Square Drive Output Shafts for BPM Wiper Motors

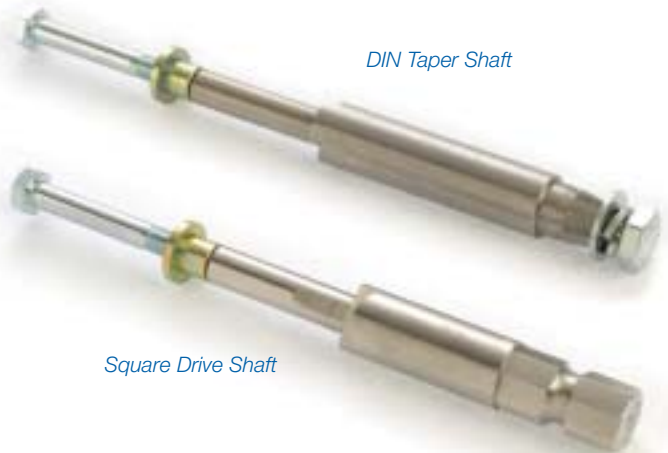
Many of the older vehicles were built with a pneumatic BPM wiper motor that was directly coupled via its stainless steel output shaft through the bulkhead and onto the DIN taper spline wiper arm. It will be seen from the adjacent illustration that the process of changing the shaft is a simple substitution of one for the other.

In cases where the wiper arm is of an arcuate type the changing of the shaft and the fitment of a corresponding arcuate wiper arm is all that is required. If however the vehicle is fitted with a pantograph wiper arm then in addition it will also be necessary to substitute a new slave arm swivel post in place of the existing swivel post as illustrated by the corresponding leaflet.
